SURVEY: CALCULATED, CHECKED DESIGN: DRAWN TRACED: APPROVED DATE: SCALE:	QUANTITY SHEET RUTLAND STATE AIRPORT CLARENDON, VERMONT AIP 3-50-0015-02
	PROJ. NO. 5181
	SHEET 1 OF 44
	 PENNHAM ENGINEERING ASSOCIATES, INC. <small>Road 214, Tull Center P.O. Box 485 Williston, Vermont 05696</small>

SURVEY: REP. L. I.	AIRPORT SITE PLAN RUTLAND STATE AIRPORT CLARENDON, VERMONT AIP 3-50-0015-02 PENN HAM ENGINEERING ASSOCIATES, INC. Route 24, Fish Creek, P.O. Box 465, Whitehall, Vermont 05481
CALCULATED	
CHECKED	
DESIGN: J.M.	
DRAWN: A.W.	
TRACED	
APPROVED: R.W.P.	
DATE: 9/15/84	PROJ. NO. 5781
SCALE: 1" = 40'	SHEET 3 OF 44

RUTLAND STATE AIRPORT

NEW ACCESS ROAD AND PARKING AREA
WITH RELATED UTILITY MODIFICATIONS

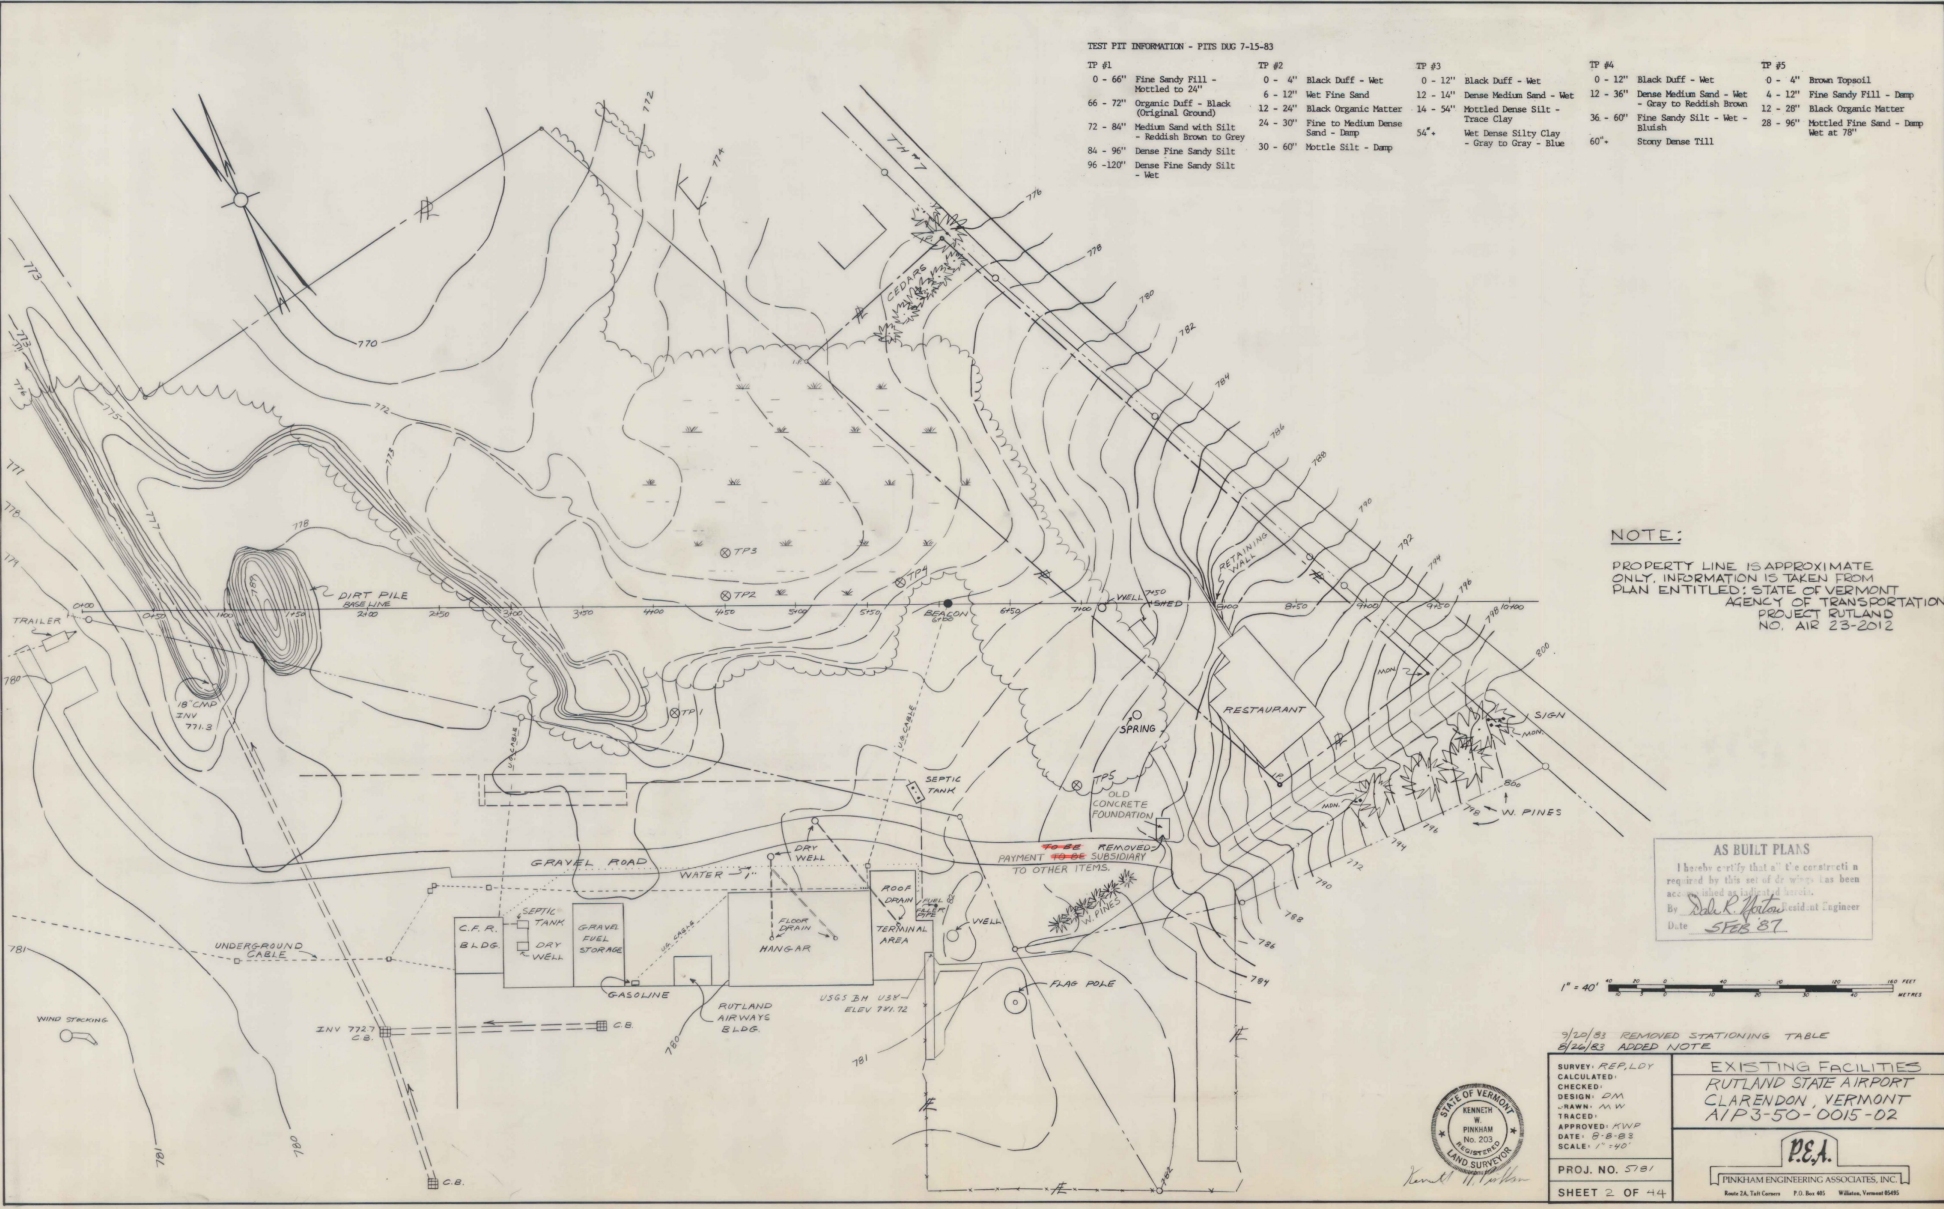
NOTE: Some of the Quantities shown above have been revised, to reflect the deletion of the Northern Access rd. from this contract. (See sheet 3 of 44)

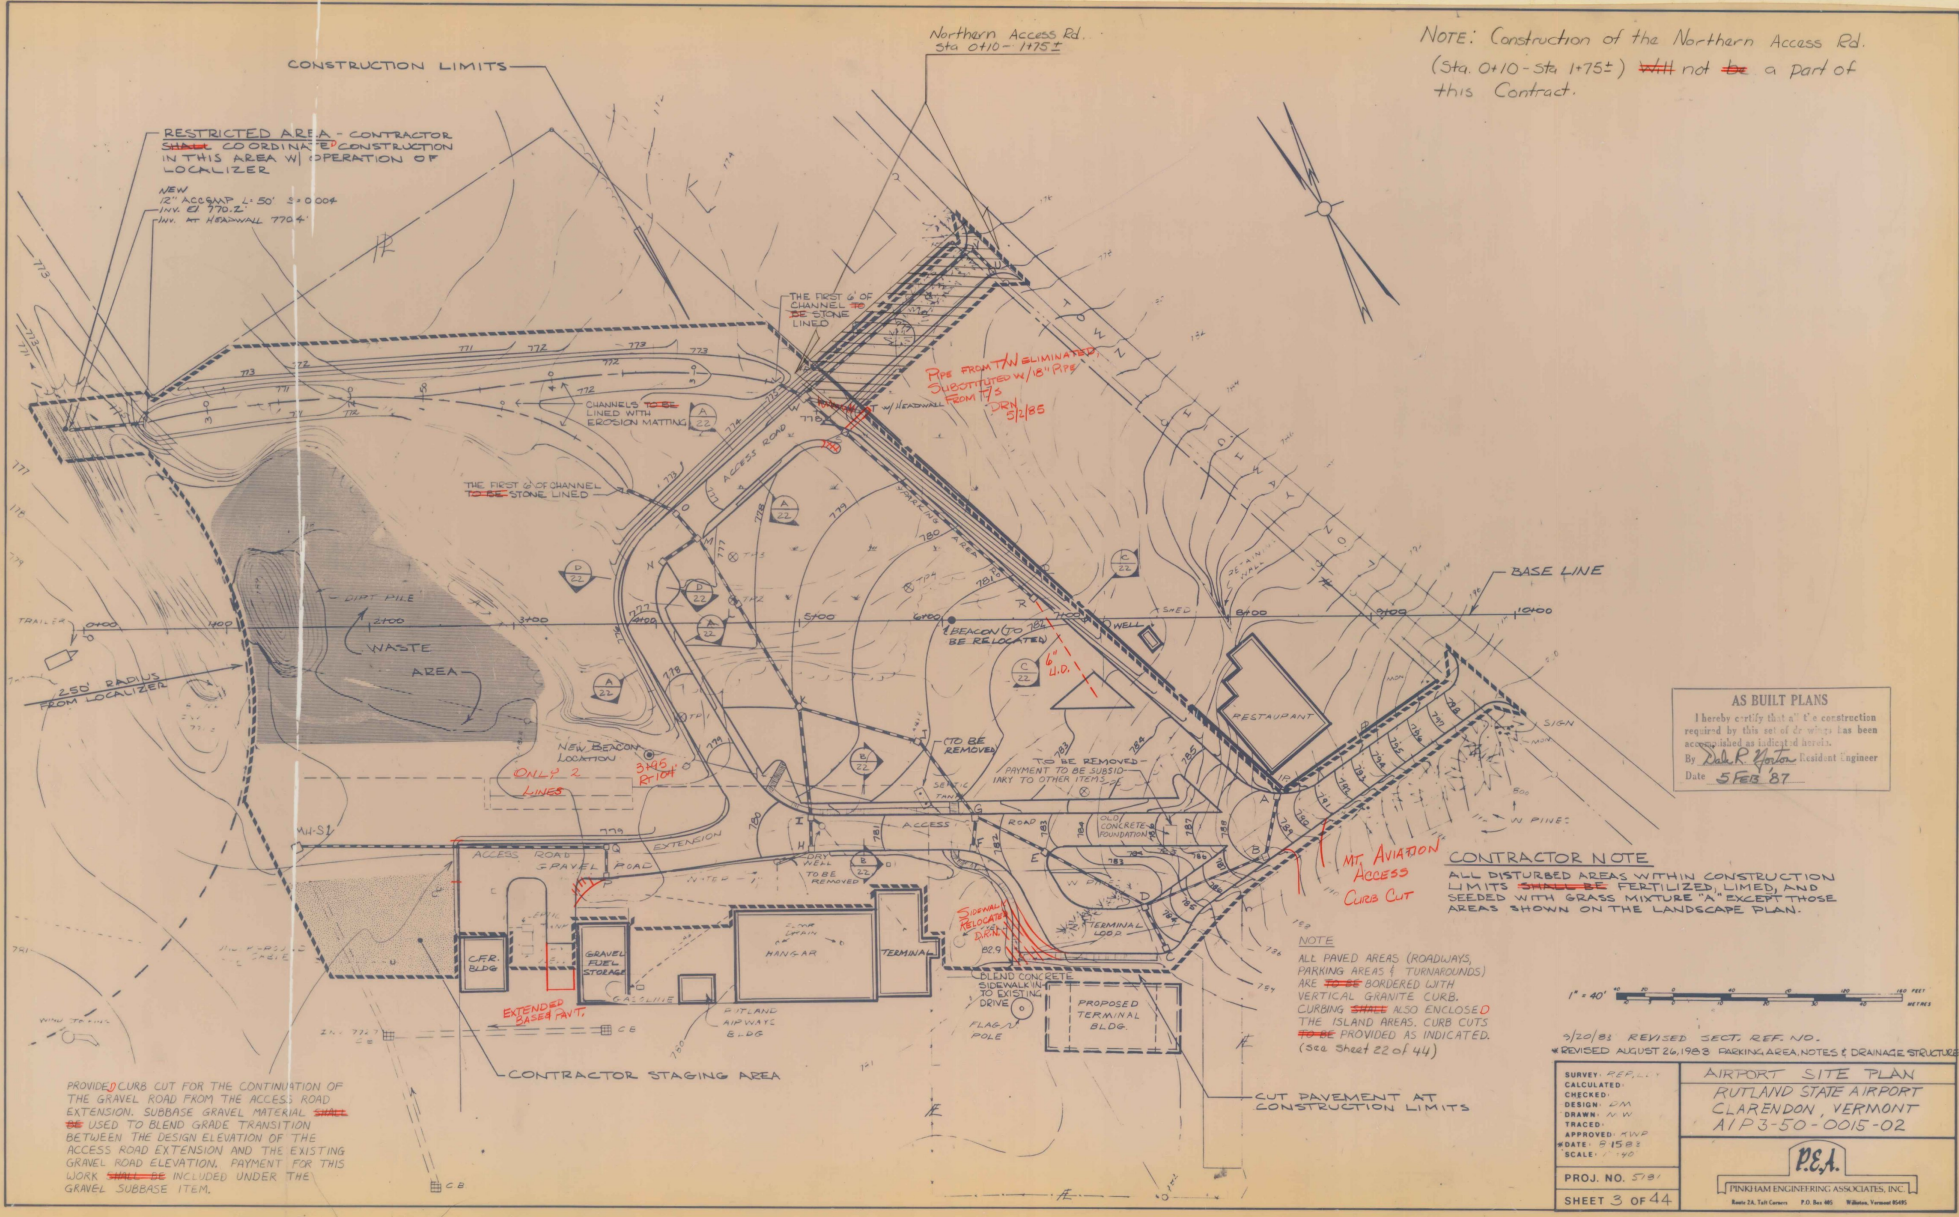
NOTE: Construction of the Northern Access Rd. (Sta. 0+10 - Sta. 1+75±) ~~will not be~~ a part of this Contract.

Pipe FROM 711 ELIMINATED SUBSTITUTED W/ 16" PIPE FROM 715 DEN 5/1/85

PROVIDED CURB CUT FOR THE CONTINUATION OF THE GRAVEL ROAD FROM THE ACCESS ROAD EXTENSION. SUBBASE GRAVEL MATERIAL ~~SHALL BE~~ USED TO BLEND GRADE TRANSITION BETWEEN THE DESIGN ELEVATION OF THE ACCESS ROAD EXTENSION AND THE EXISTING GRAVEL ROAD ELEVATION. PAYMENT FOR THIS WORK ~~SHALL BE~~ INCLUDED UNDER THE GRAVEL SUBBASE ITEM.

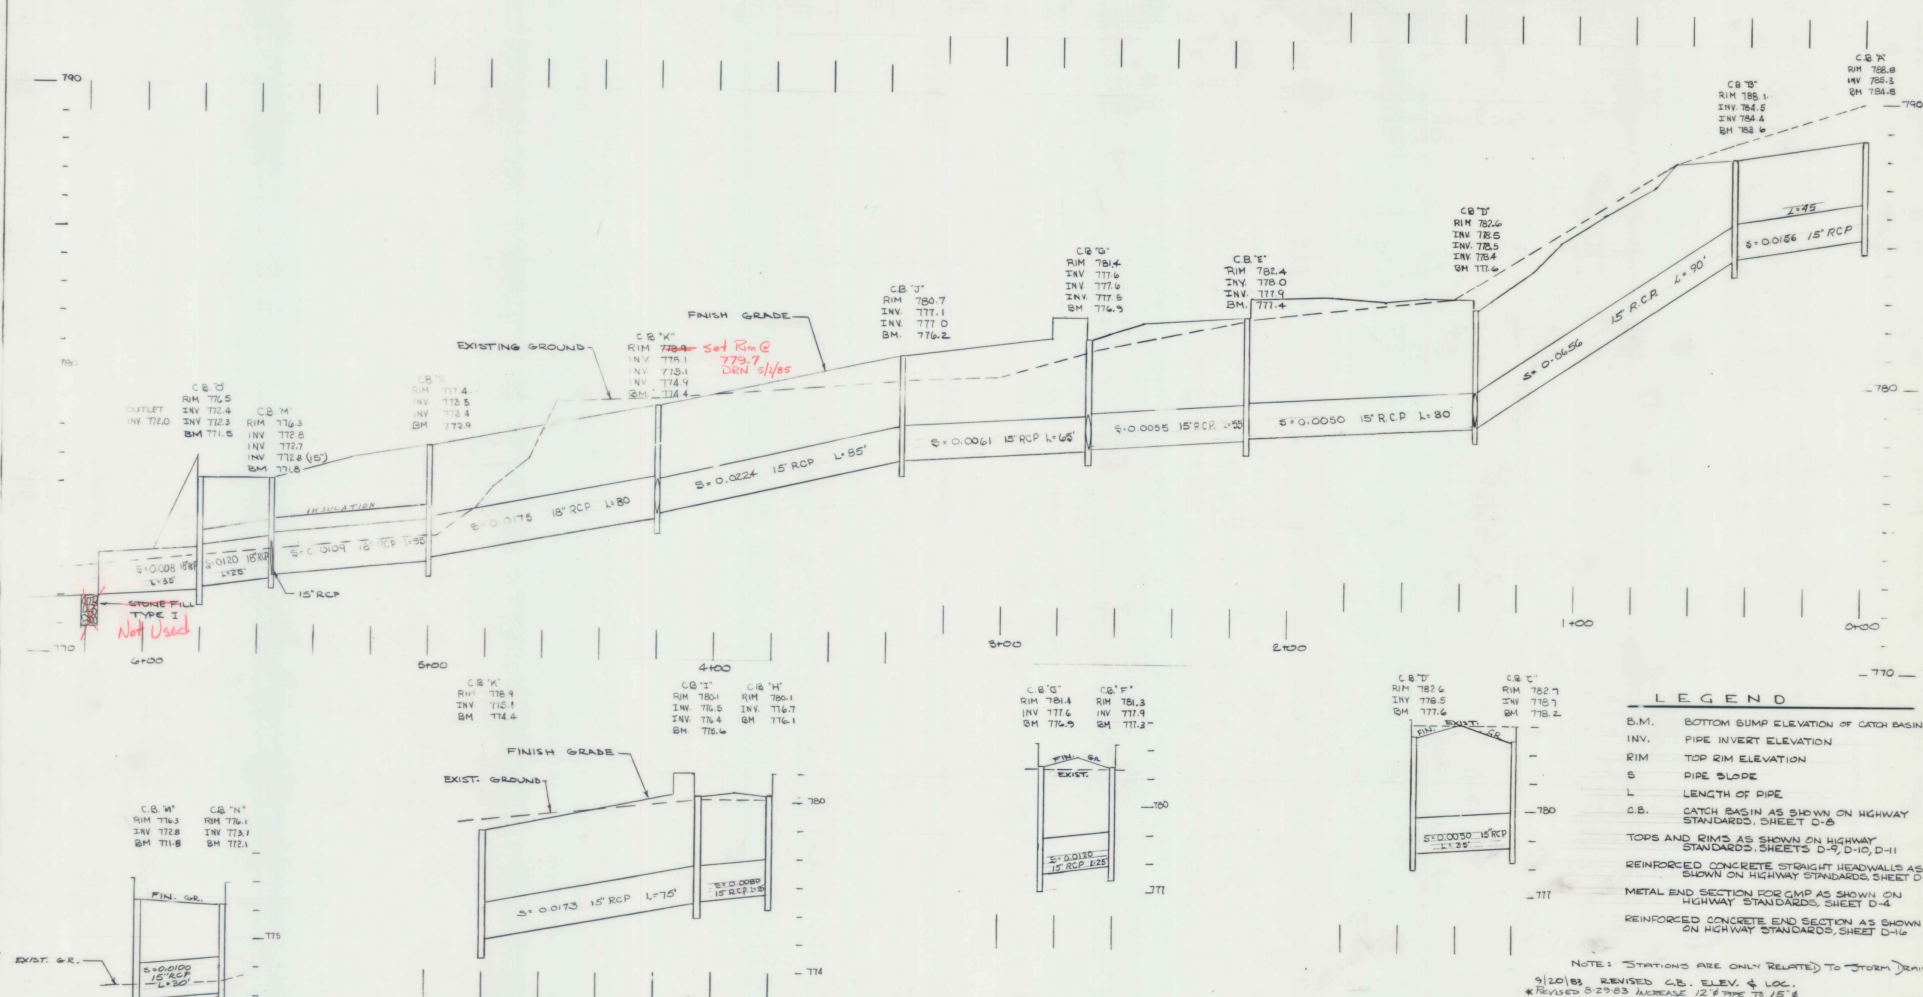
NOTE: STATIONS ARE ONLY RELATED TO STORM DRAIN
 9/20/83 REVISED C.B. ELEV. & LOC.
 *REVISED 8-29-83 INCREASE 12" PIPE TO 15"

NOTE: STATIONS ARE ONLY RELATED TO STORM DRAINS
 3/20/83 REVISED C.B. ELEV.
 * REVISED 8/29/83 INCREASE PIPE SIZES.
